Airways New Zealand submission to the Civil Aviation Authority's 2016 Manawatu Airspace Review

Prepared by: John Wagtendonk
Policy, Standards and Safety Improvement

26 February 2016

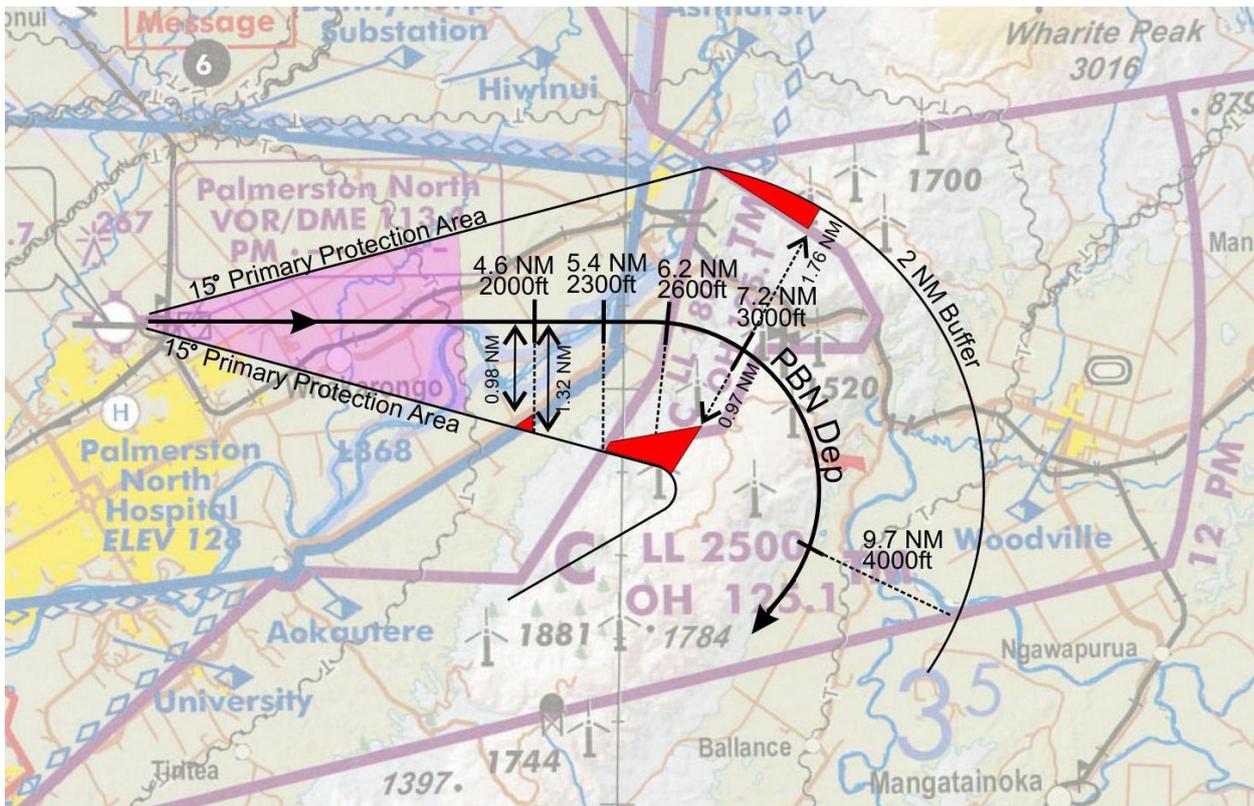
The diagram below depicts the proposed PBN departure that turns right off PM RWY 07. The containment criteria applied is the 15 degree primary protection area until it reaches 2 NM wide; thereafter it is a 2 NM buffer.

The diagram depicts some profile levels on the departure – i.e. at 4.6 NM, the profile level is 2,000ft AMSL, at 5.4 NM 2300ft, at 6.2 NM 2600ft at 7.2 NM 3000ft and at 9.7 NM 4000ft.

Bearing in mind that the departure profile needs to be at least 500ft above the lower limit of the airspace, the diagram above depicts 3 areas (in red) where the existing airspace does not fully contain the departure. These are;

1. The PM CTR needs to contain the departure until the profile passes 2000ft at 4.6 NM. This doesn't happen. Where the profile passes 2000ft, the CTR should be 1.32 NM wide but the existing CTR is only 0.98 NM wide – 0.34 NM less than it needs to be. A small triangular shaped increase in the CTR would be needed for full containment.
2. On the inside of the turn, between 5.4 NM and 7.2 NM the containment buffer reduces to 0.97 NM.
3. On the outside of the turn, between 6.2 NM and 7.2 NM the containment buffer reduces to 1.76 NM.

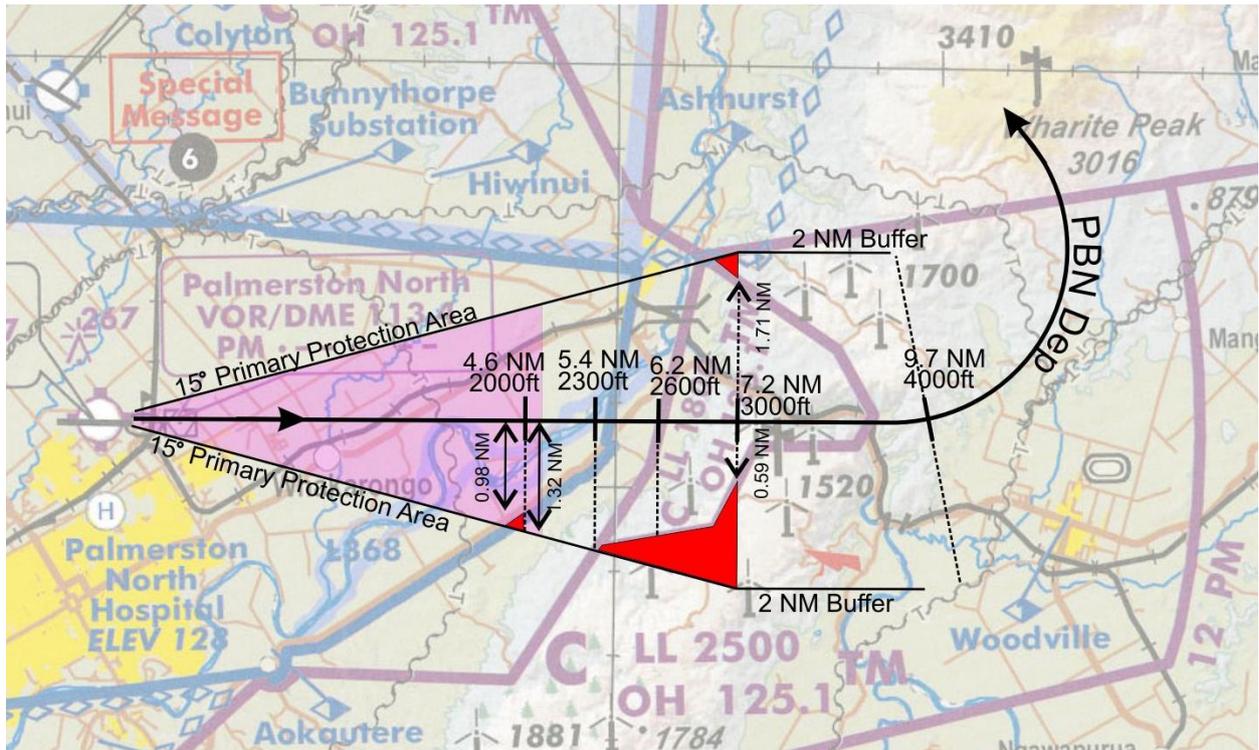
The proposed PBN departure to the north also has containment issues with the existing airspace as indicated in the diagram below by the red areas.

The lack of containment by the CTR is the same as for the right turning departure.

Between 5.4 NM and 7.2 NM, containment to the south reduces to 0.59 NM. To the north it reduces to 1.71 NM.

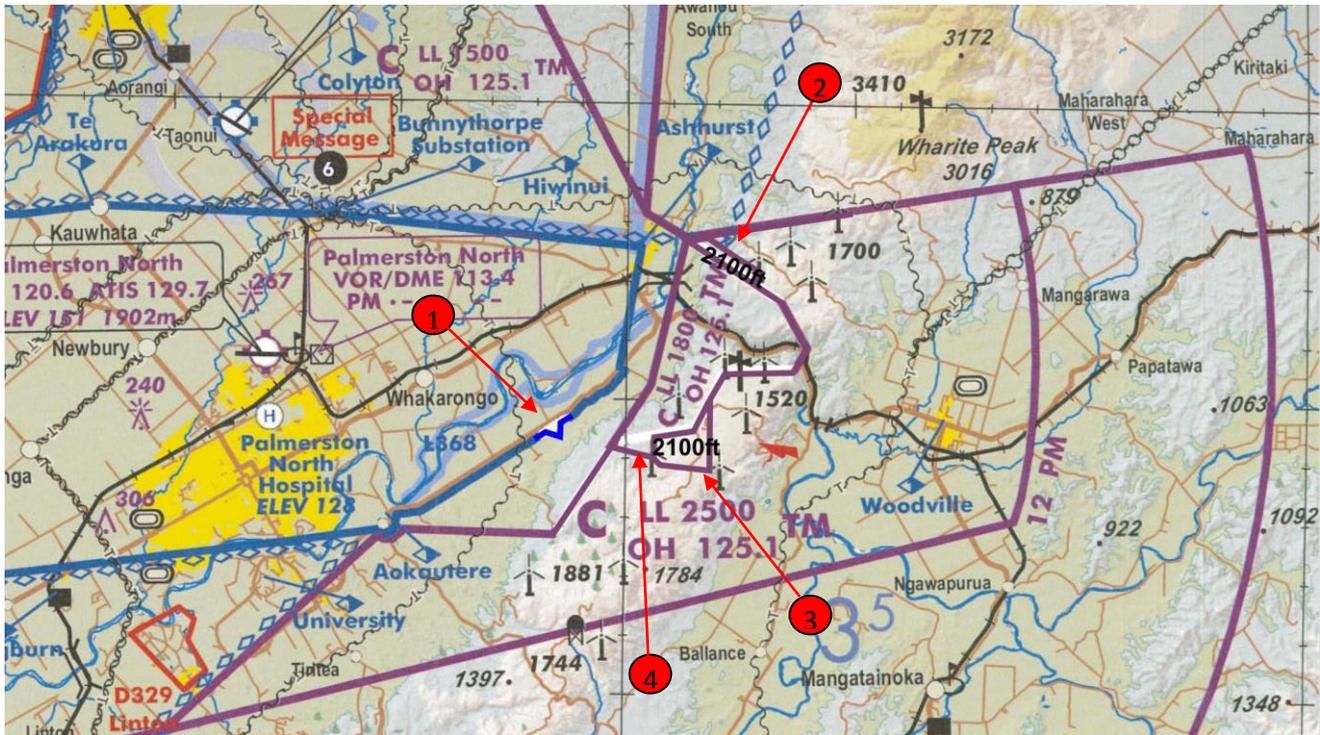
To provide full containment of the proposed new PBN departures off PM RWY 07 the PM CTR and OH CTA would need to be amended as depicted in the diagram below. This adds;

1. a small triangular increase to the PM CTR along the south-eastern boundary; and
2. a new CTA portion LL 2100 ft east of Ashhurst; and
3. a new CTA portion LL 2100 ft along the ranges south of the Manawatu Gorge; and
4. a small extension of the existing CTA LL 1800 ft to the south

Incorporating the 2100 ft CTA portions into the existing 1800 ft CTA is not possible as the CTA would be less than the required 700ft above the surface of the earth.

1. change the PM CTR and OH CTA to include the additional airspaces in order to provide full containment of the PBN departures; or
2. leave the PM CTR and OH CTA boundaries where they currently are and accept the reduced airspace containment of the PBN departures; or
3. leave the PM CTR and OH CTA boundaries where they are and advise Airways that PBN departures need to be fully contained. This would preclude the implementation of the proposed PBN departures. CAA should also consider the lack of containment of the existing departures and the only alternative then is to increase the climb gradient to more than 6.5%.
